City Planning Commission
Sacramento, California

LOCATION: East side of Center Parkway, approximately 1,500 feet south of Jacinto Road

APPLC.NO. P90-420

MEETING DATE May 23, 1991

TENTATIVE MAP

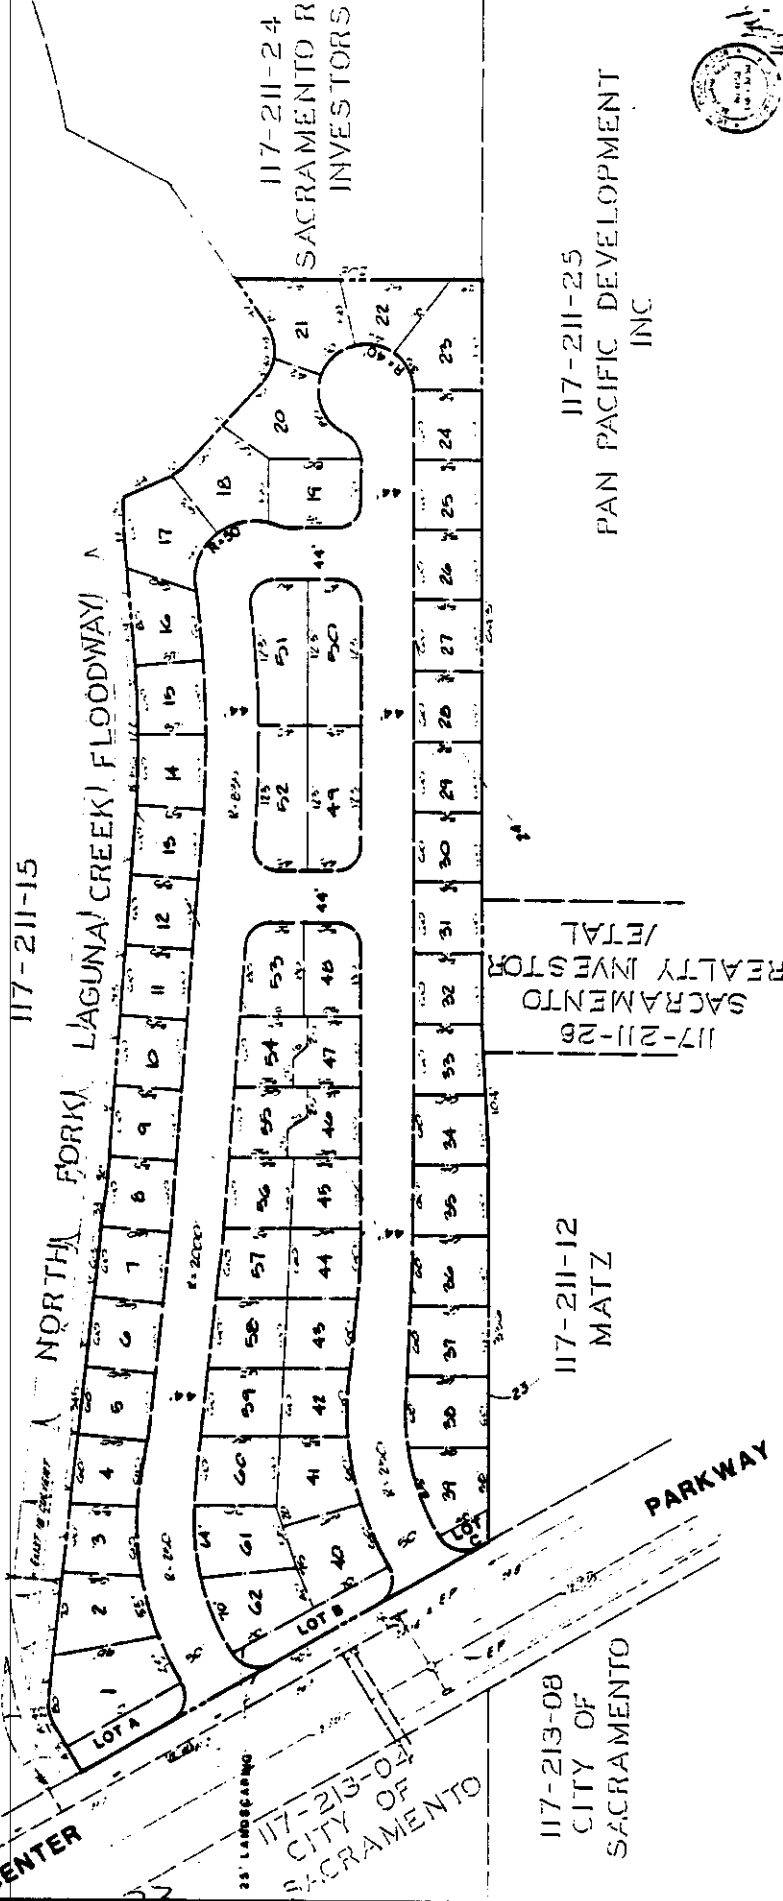
The proposed tentative map includes 62 single family lots and three landscape lots along Center Parkway. The access to the residential parcels is a loop street as access to the site. The typical lot size is 60 feet by 60 feet. Staff recommends approval of the proposed tentative map for a single family subdivision due to its consistency with the amended multiple family zoning and plan designations of the site.

1. Provide standard improvements pursuant to Section 40.811 of the City Code. Access from Center Parkway will be limited to right turns in and out only. Both access streets shall intersect Center Parkway at 90 degrees to the satisfaction of the Traffic Engineer and shall be a 50 foot right of way for a minimum of 200 feet east of Center Parkway;
2. The applicant shall construct all remaining improvements of Center Parkway adjacent to this parcel including median islands and roadway west of median islands;
3. Submit a soils test prepared by a registered engineer to be used in street design;

2. A 6 foot high noise barrier shall be constructed along the property line on Center Parkway. The barrier should extend along the west property lines of lots 1, 61, 40, and 39. Specifically, for lots 1 and 39 the wall must begin at the front set back and wrap around the rear lot lines for a minimum of 15 feet.
